ATWS MITIGATING SYSTEM ACTUATION CIRCUITRY (AMSAC)
RESPONSES TO REQUESTS FOR ADDITIONAL INFORMATION

POWER AUTHORITY OF THE STATE OF NEW YORK
INDIAN POINT 3 NUCLEAR POWER PLANT
DOCKET NO. 50-286
JANUARY 11, 1982

ATWS MITIGATING SYSTEMS ACTUATION CIRCUITRY (AMSAC) LOGIC DIAGRAM

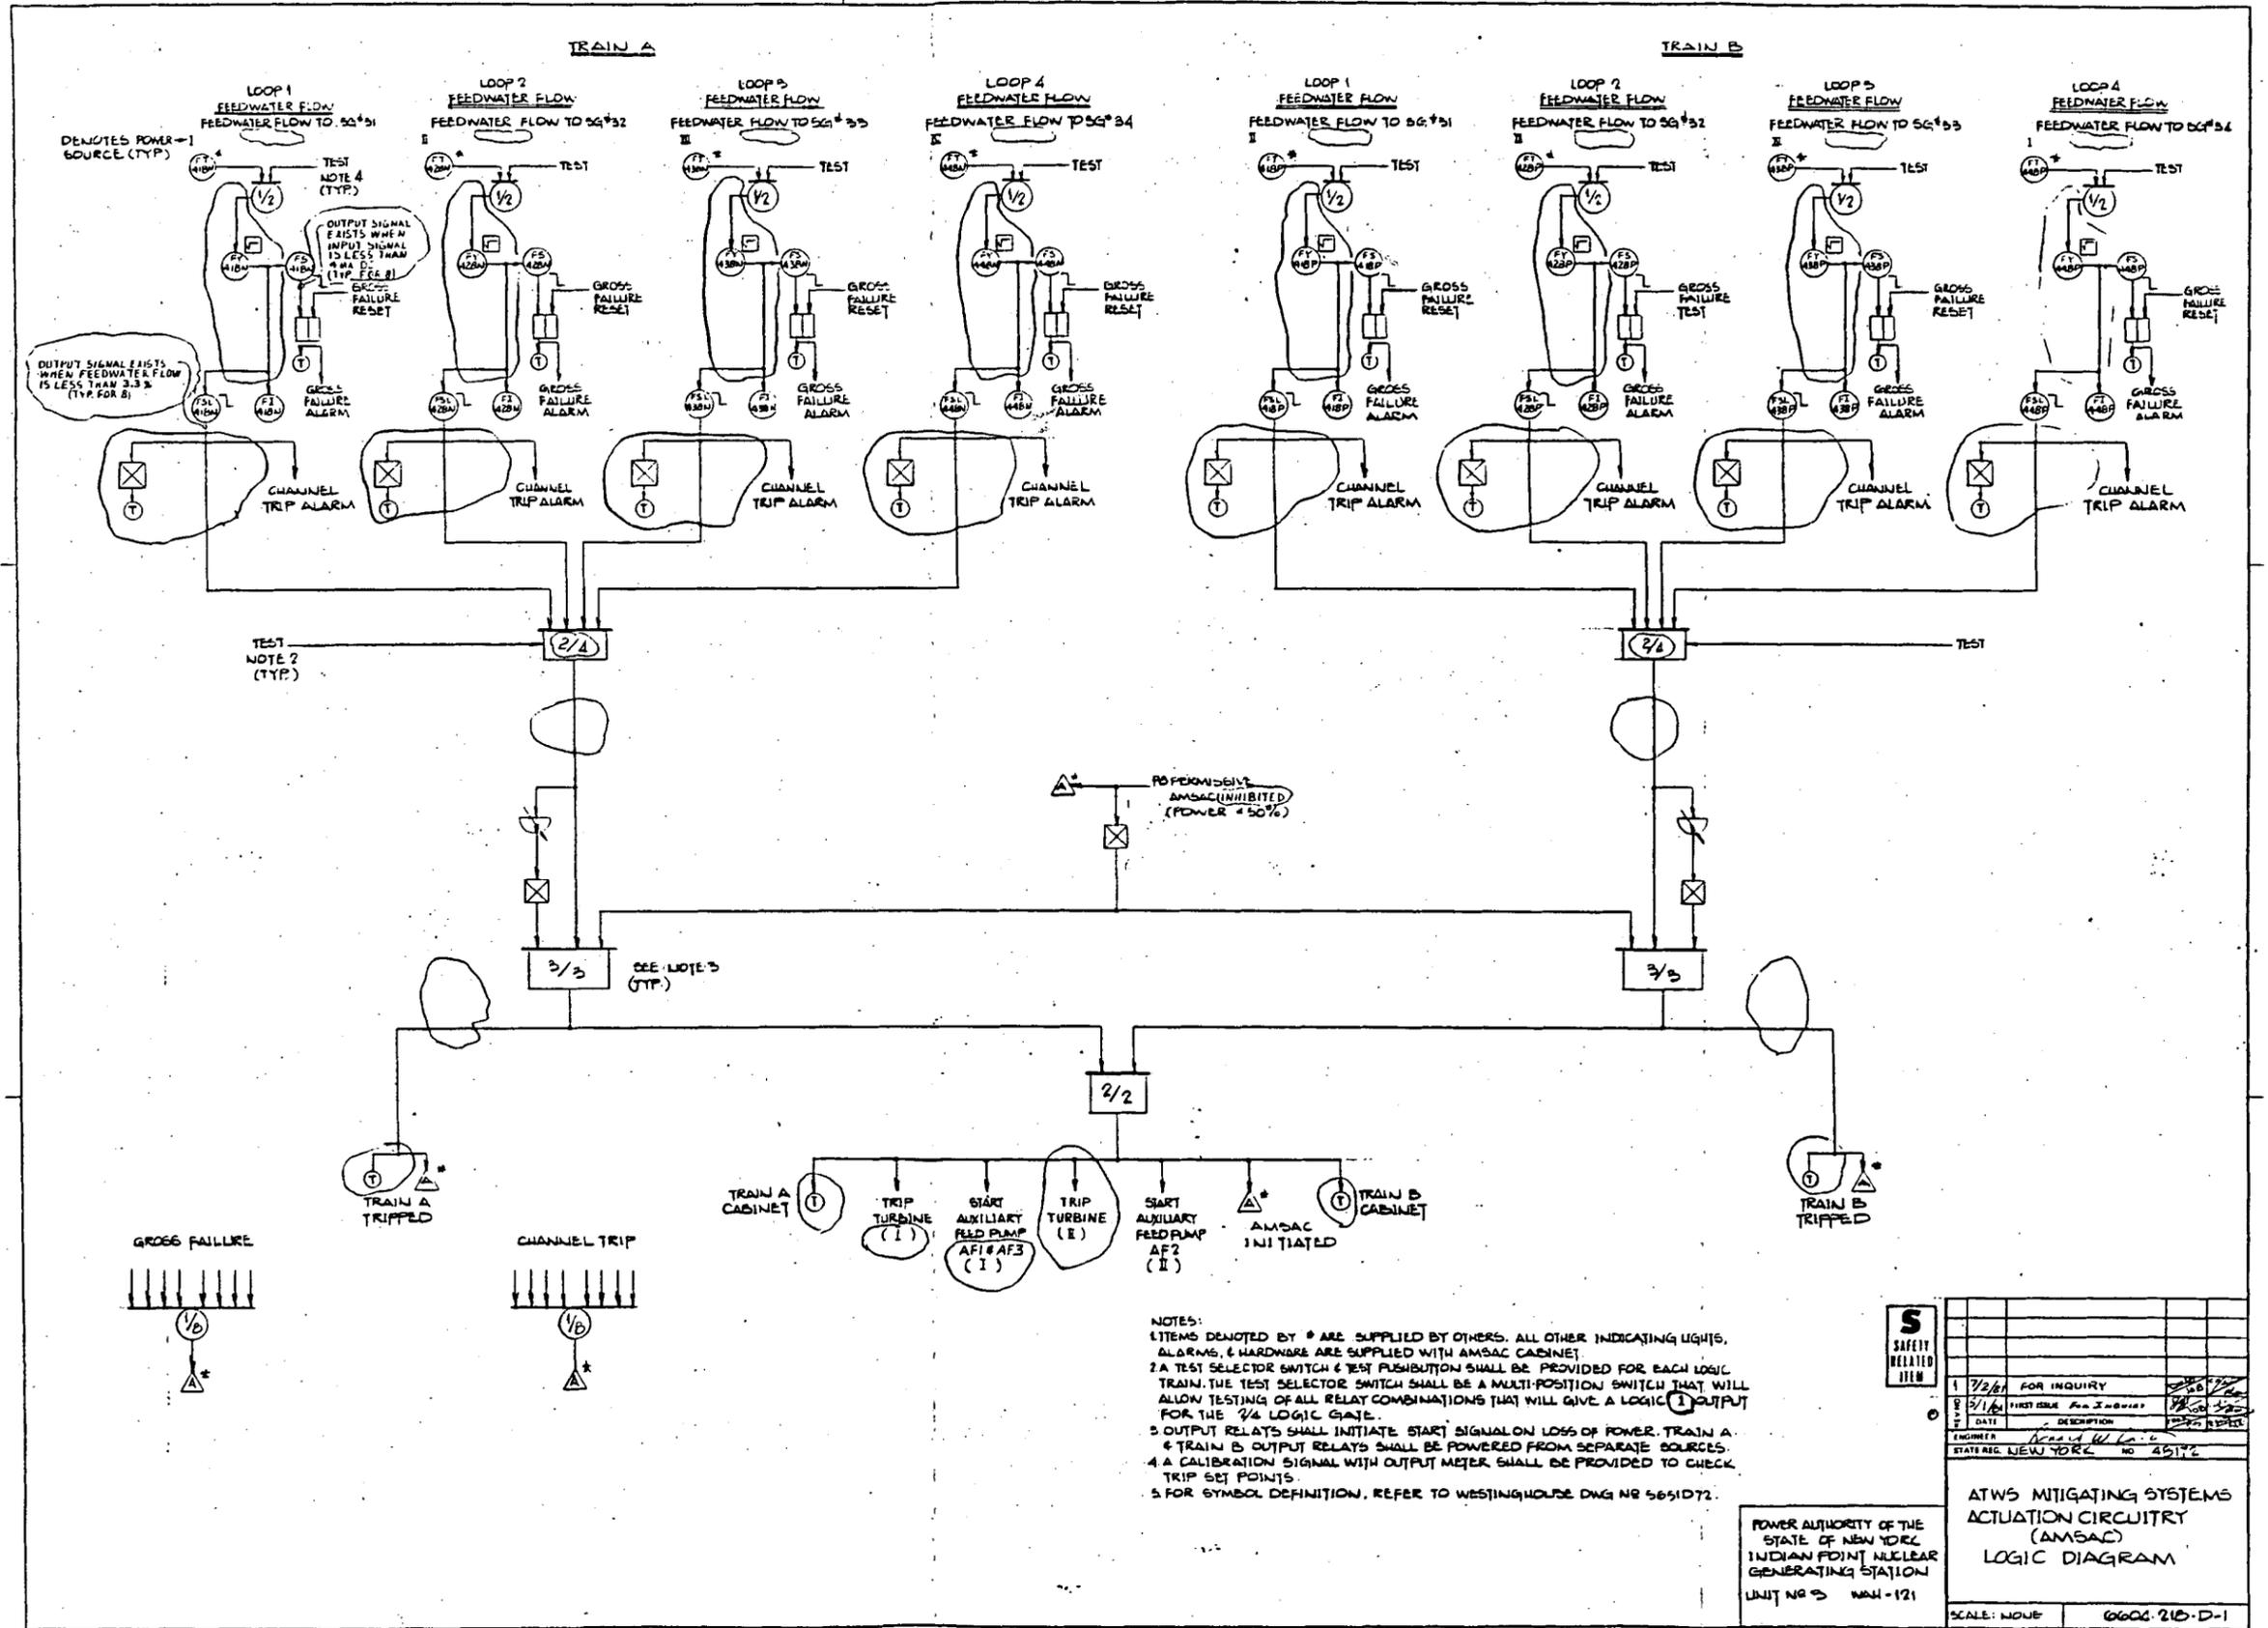
5. Discuss the independence (physical separation and electrical isolation) provided between AMSAC actuation channels.

9. Provide elementary schematic/wiring diagrams for the Indian Point Unit 3 AMSAC showing:
 - a. initiation circuits
 - b. annunciation/indication circuits
 - c. permissive (50% power)
 - d. any manual overrides/resets

AMSAC consists of two independent, separated and redundant actuation channels. Separate sensors (transmitters) and logic cabinets are dedicated to each channel. The two channels are brought together in the final 2 out of 2 gate (refer to attached sketch) that initiates the actuation circuitry. The coincidence is provided to prevent spurious tripping of the plant since both AMSAC channels actuate on loss of power.

Since the final design has not yet been completed, the above drawings are not available for submittal. The AMSAC Logic Diagram, however, has been finalized and it has been attached for your review.
